1 **SECTION 623 – TRAFFIC SIGNAL SYSTEM**

2
3 Make the following amendments to said Section:

*HWY-K-03-18
Figure 2*

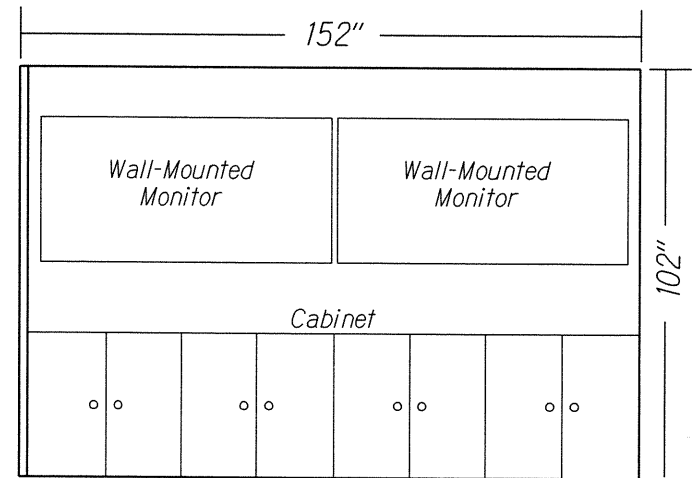
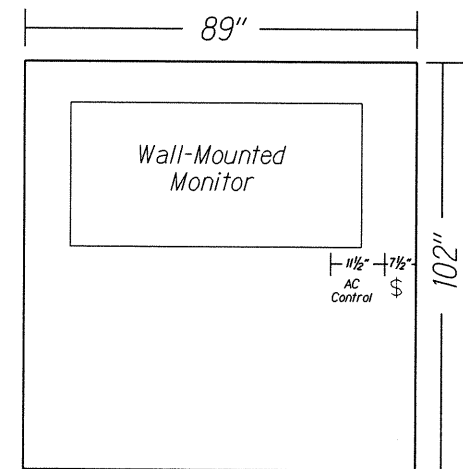
27
28 **“(15) Traffic Management Center (TMC).** Install a traffic management
29 center in a select room at the Department of Transportation Kauai
30 Baseyard, as directed by the Engineer. The traffic management system will
31 consist of servers, monitors, workstations and all necessary hardware
32 including, but not limited to, network switches, and hardwiring to operate
33 existing Centracs software in accordance with the contract documents.
34 Contractor to coordinate with HDOT to configure TMC software and traffic
35 signal system communication and ensure that all components are operating
36 accordingly.

37
38 A general layout of the TMC is shown in Figure 2 and is subject to change
39 upon approval by the Engineer. Furniture shall be office-modular with quality
40 similar to existing, installed to maximize space as shown in Figure 2. The
41 Contractor shall provide a submittal layout of the TMC room to the Engineer
42 for approval.
